CITY OF NAPOLEON - BUILDING DEPARTMENT

RESIDENTIAL PLAN CORRECTION SHEET

ADDENDUM TO Permit No. 01468-(1)
Owner KEN RETZIG
Contractor MIKE AUVERMILLER
Location 215 FIFTH ST.

FIELD CORRECTION NOTICE

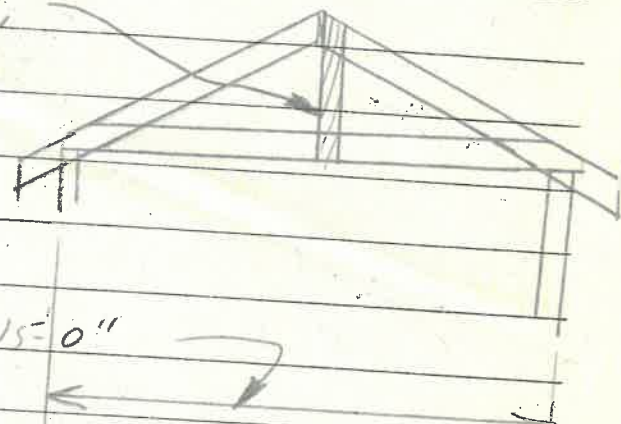
Upon inspection, violations of the C.A.B.O.

Sec. TABLE 7-B were in evidence.

The following orders are hereby issued for their correction: INSTALL 1x4 TIES @ 16" O.C. BETWEEN THE RAFTERS AT THE RIDGE AND THE CEILING JOISTS.

NOTE: MAX SPAN FOR 2x6

SPF CEILING JOISTS @ 16" O.C.

ROOF PITCH OVER $\frac{3}{12}$ = 13'-3"

ACTUAL SPAN FOR THIS STRUCTURE = 15'-0"
